ORIGINATION FORM -

Proposed Revisions to a Standard Plans Index

Index Number: 440-001 Sheet Number (s): 1, 2, and 3 of 3 Index Title: Underdrain

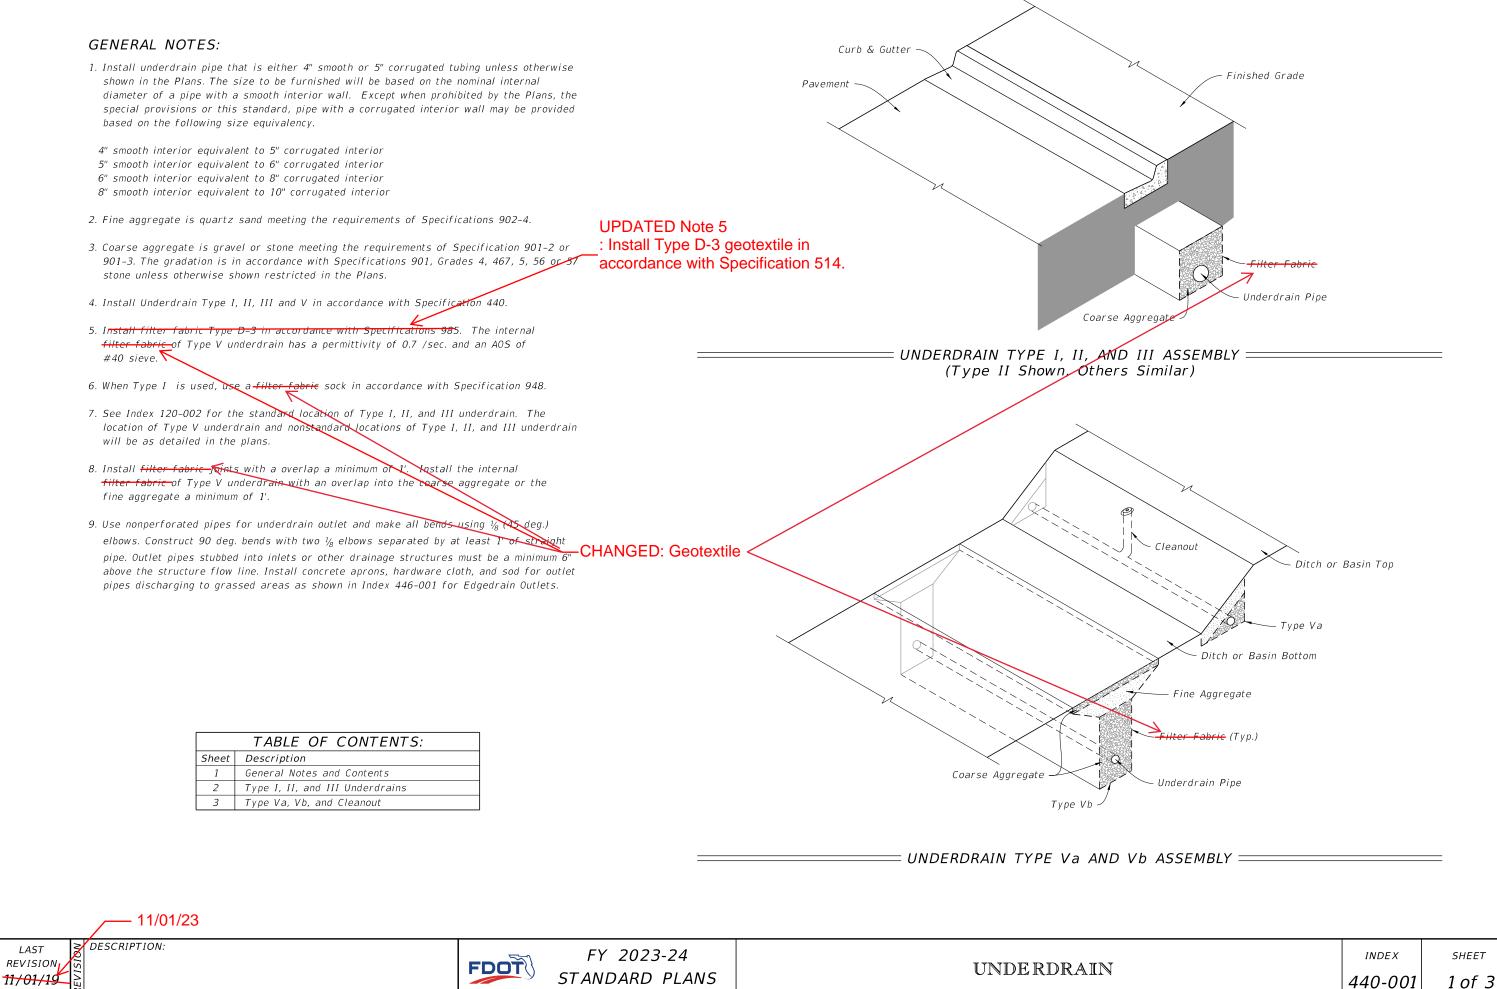
- Sheet 1: Updated GENERAL NOTE 5 "Install Type D-3 geotextile in accordance with Specification 514."; Changed all references of "Filter Fabric" to "Geotextile".
- Sheet 2: Changed all references of "Filter Fabric" to "Geotextile".

Sheet 3: Changed all references of "Filter Fabric" to "Geotextile".

Areas of the Standard Plans where 985 is referenced for drainage details needs to now reference Specs 514 (Division II specs). The Contractor is not responsible for the producer requirements division III specs, but ensure that the product used is on the APL and used for appropriate intended use. Specs 514 essentially does reference 985 to meet the materials requirement.
